CERTIFICATE OF APPROPRIATENESS

Property: 1021 Harvard Street, Lot 7, Tract 8A, Block 217, Houston Heights Subdivision. The property includes a historic 3,275 square foot, one-story wood frame single-family residence situated on a 9,900 square foot (75' x 132') interior lot.

Proposal: Alteration – Construct a screened side porch with a shed roof on the south side of the residence. See enclosed application materials and detailed project description on p. 5-10 for further details.

SOUTH SIDE ELEVATION

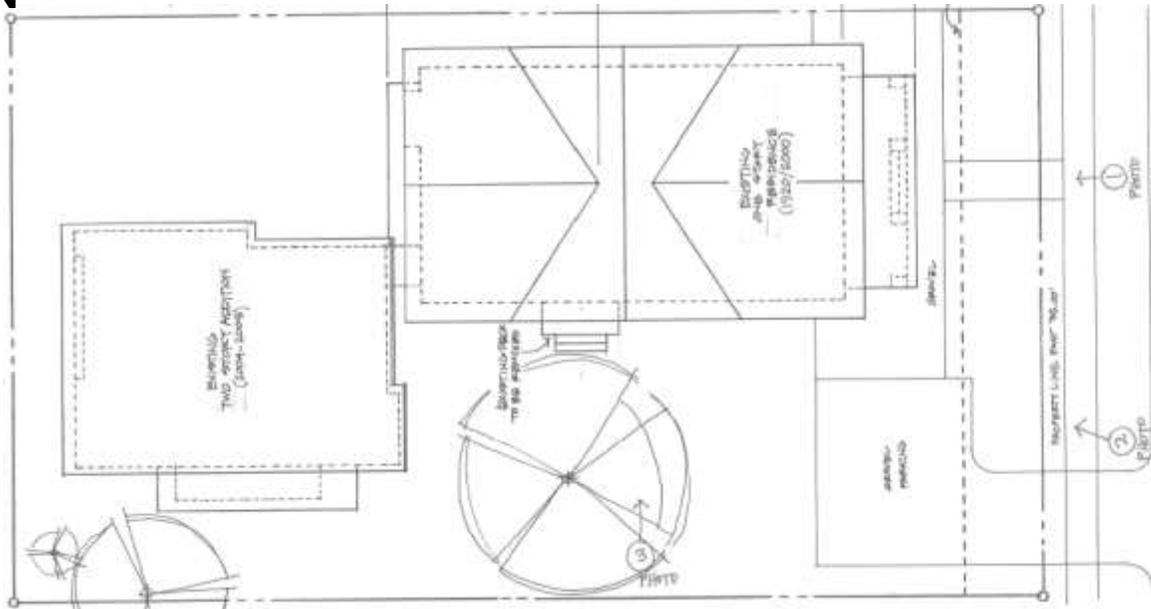
I have NO OBJECTION to this proposed porch addition to this contributing structure. There is sufficient differentiation between the visual character of the existing historic structure and the proposed addition. With the proposed attachment indicated, the additional porch is removable in the future should that be desired.
